MEETING OF THE
HIGHWOOD PLANNING AND ZONING COMMISSION

Wednesday May 21, 2025

4.1 Petition for a Planned Unit Development from Allan Dennis, of Midwest Young Artists (MYA). The petitioner has applied to permit the use of vacant land, parcel #16-10-401-014 in Highwood IL, 60040 to be used as a concert hall and musical campus.

Subject: Resubmittal of Request for Zoning Change

CONCEPTUAL PLAN #2 | DESIGN: J.K. | DRAFTING: S.R.M. | SCALE: 1" = 30' | DATE: 11/11/24

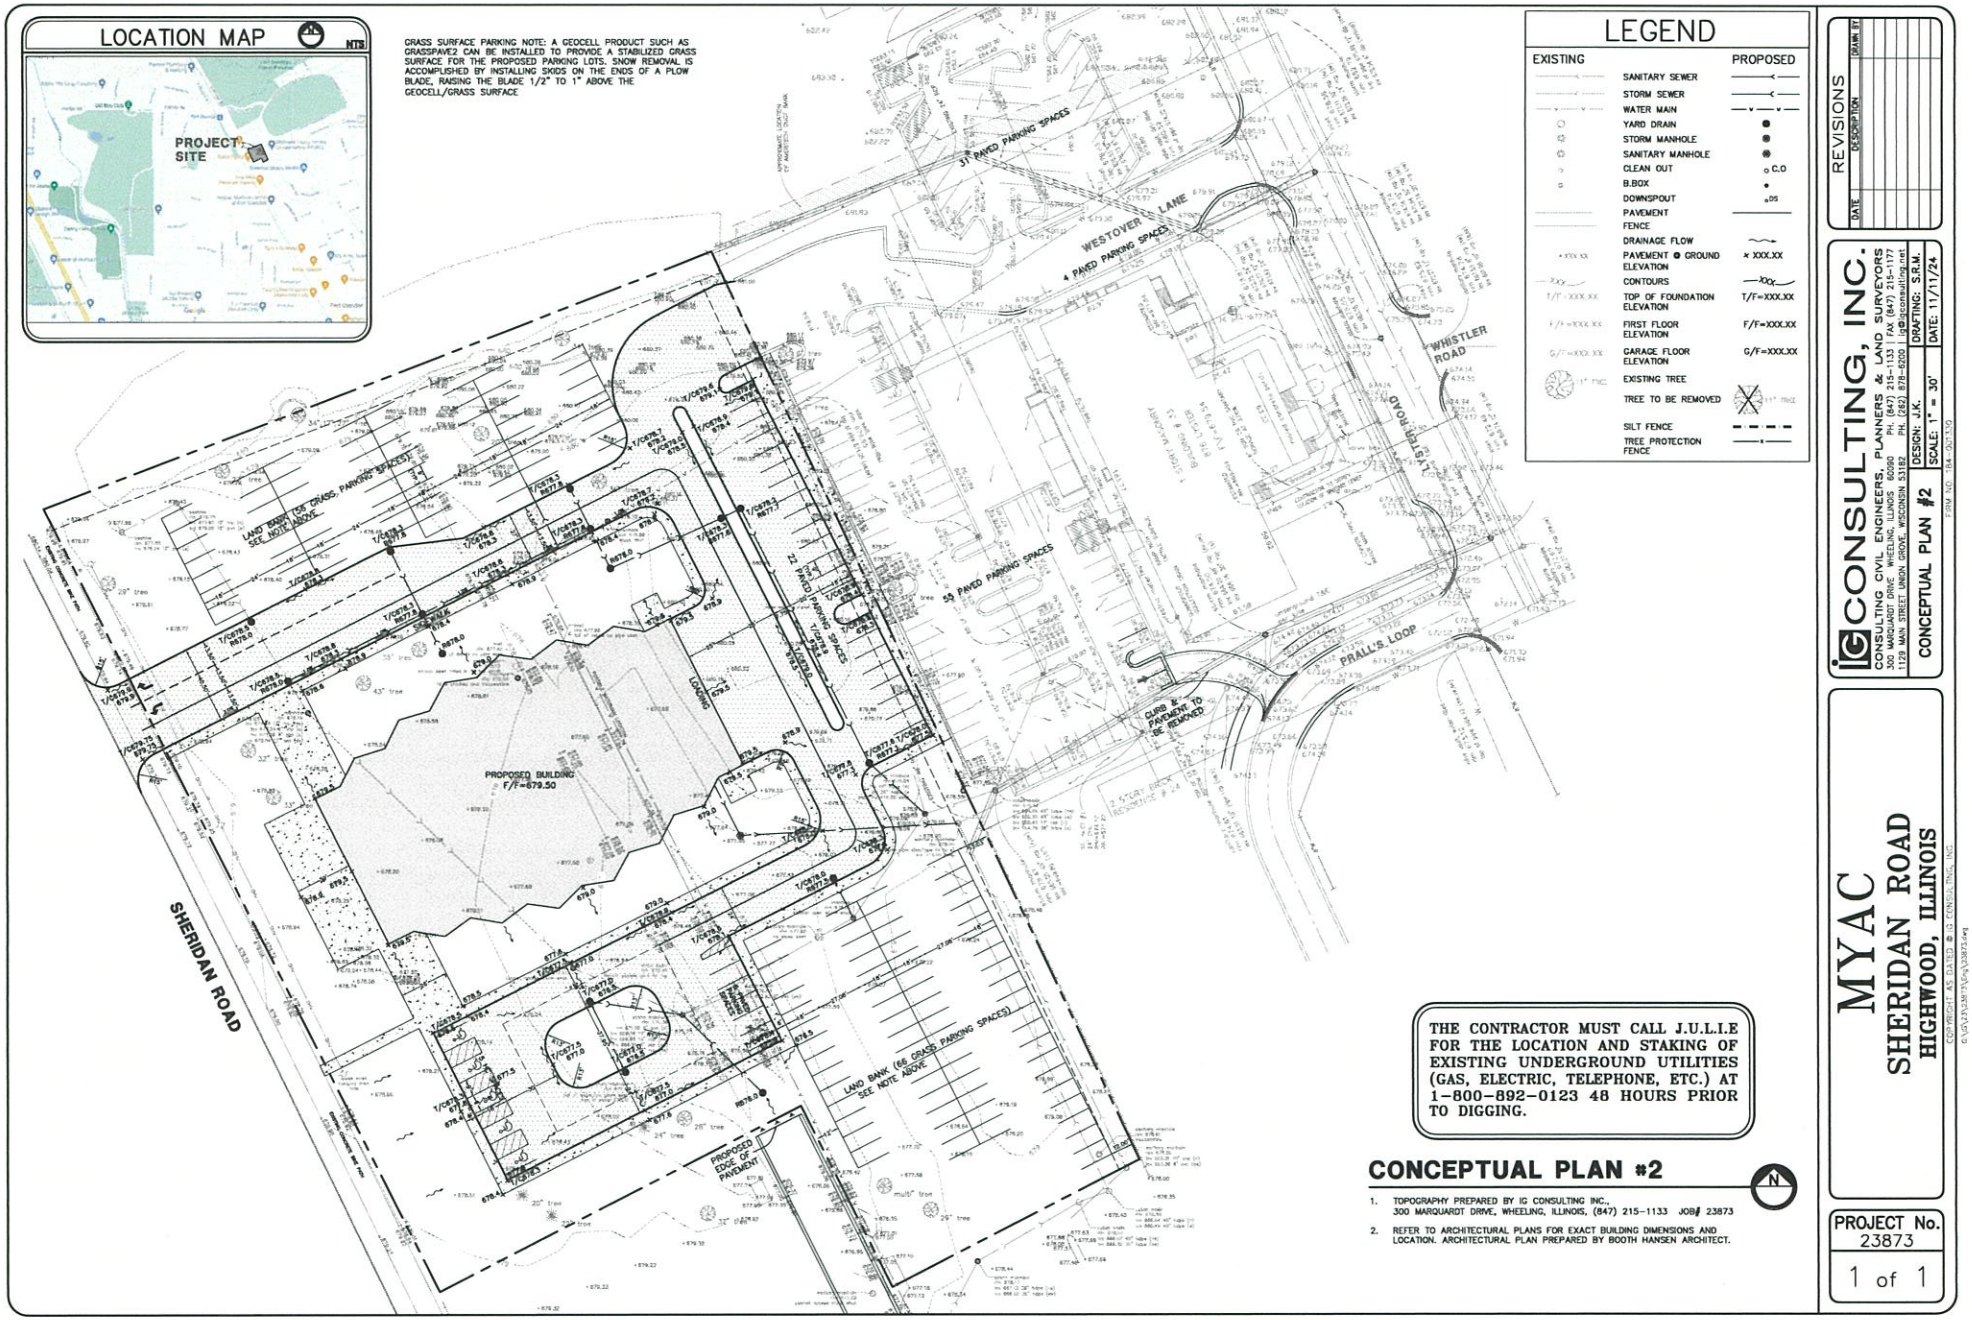
Dear Scott
We have reviewed the Traffic and Parking Management Plan for Large Events, and Conceptual Plan #2. Our Traffic Operations staff has reviewed the Traffic and Parking Management Plan for Large Events. Our Municipal staff has reviewed the Conceptual Plan #2 as well. Based on our teleconference of April 23, 2025 and follow-up correspondence from Kevin Lewis of IG Consulting, we offer the following:

Conceptual Plan #2:

1. The traffic impact study (TIS) and large event parking plan are acceptable.
2. We find the Concept Level Engineering Plans to be generally complete and acceptable for concept level plans.

3. A Watershed Development Permit is required if more than 3 acres of land is hydraulically disturbed. Please refer to Article 3.300.06 of the Lake County Watershed Development Ordinance. This shall be submitted with final engineering plans. Based on our discussions and supplemental information provided, there is an agreement that the final design will be in full compliance with City and Lake County codes and stormwater detention will be provided on site. Several alternatives are being considered for stormwater detention storage, including but not limited to, an underground stormwater vault or chambers, and the release of stormwater will be restricted as required.. We understand that the City will not issue development permits until final engineering plans and reports provide documentation that the proposal is in compliance with City and Couty codes. The proposal will not include storage within the existing regional stormwater basin east of the site.

3. With final engineering plans all City utilities along Westover Road shall be shown as either re-routed or removed. This will also include any utilities shown running under the proposed building.

4. A Watershed Development Permit is required if more than 3 acres of land is hydraulically disturbed. Please refer to Article 3.300.06 of the Lake County Watershed Development Ordinance. This shall be submitted with final engineering plans.

9. The plans show the parking lot exit onto Prall's Loop as being removed. This shall be included in the final engineering submittal with more detail.

Response: All necessary removal or re-routing of Westover Lane utilities, including utilities under the proposed building, will be indicated in the final engineering drawings. Easement will be created where necessary.

Response: As we have reviewed together, we have developed a preliminary storm water management concept to include a chamber or vault system on the site to restrict the release of on site storm water runoff. The Offsite Basin will not be used for the project stormwater management. A watershed development permit application will be completed and submitted with final engineering drawings.

Response: Fire hydrants are shown. Locations will be designed based upon a 400-foot radius of protection. Please see our revised exhibit depicting a proposed water main and fire hydrant.

Response: Documents and drawings listed from A to J in the CBBEL letter will be provided to the City for review as part of final engineering submittal.

Response: Details for the permeable Geocell product will be provided in the final engineering submittal.

Response: A detail shall be provided for pavement removal and restoration, to close Westover Lane at Lyster Road, as well as Westover Lane at the south end of the site. Dead end signage will be provided at the south end of Westover Lane.

Response: In final engineering, additional details shall be provided for removal and restoration of the parking lot exit to Prall's Loop.

Response: Barrier curb shall be indicated, where Westover Lane will end at the south end of the site.
